Request Summary

- Design Review and Variance applications for a temporary gravel parking lot
 - Zoning Code does not permit gravel lots anywhere in City
 - Variance required
 - 23,022 SF gravel lot with ~60-70 parking spaces
 - 21 ft from front property line along Hamilton Rd
 - Setback variance required
 - Applicant states lot is for overflow parking for Sunday service
 - Lot was originally going to be removed in summer 2024 when construction began on the new addition, but removal has been pushed back to fall 2024 by applicant

Gravel lot

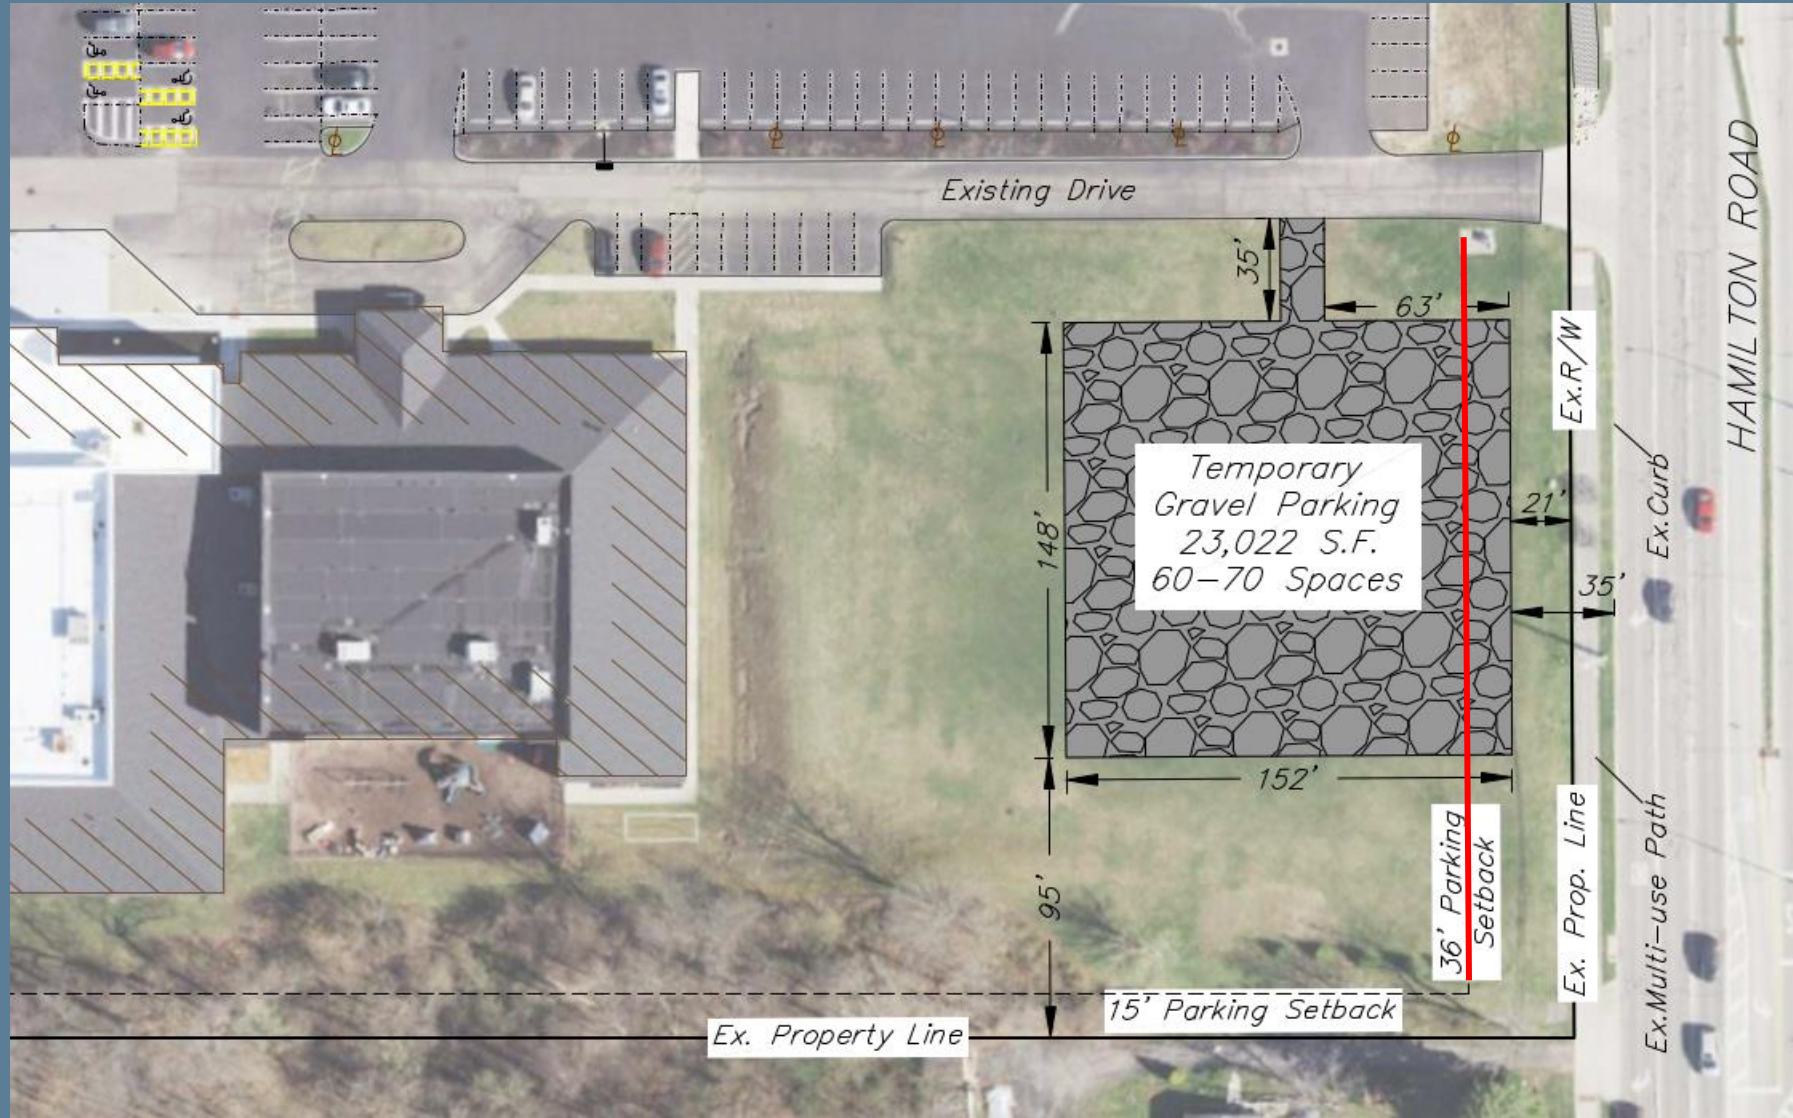
- Staff recommends disapproval of the Design Review
 - There are no other gravel lots in the immediate area and it is very visible from Hamilton Rd since there is no existing screening and it encroaches 15 ft into the front parking setback
 - Most previously approved gravel lots were in industrial areas, and most were approved as temporary lots
 - Multiple temporary lots were not removed and exist years past the approved timeline (1655-1675 Eastgate Pkwy was supposed to be removed in 2018)
 - If approved, PC may add conditions for a strict timeline and/or screening
 - PC added a condition to the April 2023 parking lot application for increased screening, and this has not been met by the applicant
 - Code Enforcement action due to resident complaints; in progress
 - Conditions can be hard to fully enforce

- Staff recommends disapproval of the following variances:
 - Ch 1154.03(a)(7) – Parking lots must be 36 ft from the ROW
 - Ch 1163.05(a) – All parking lots must be hard-surfaced
- If the DR is approved, Staff recommends approval of the following variances:
 - Ch 1163.06 – Parking areas must provide adequate lighting
 - Ch 1163.08(b-g) – Interior landscaping requirements
 - Ch 1167.18(b)(1) – Parking areas must be screened from residential lots
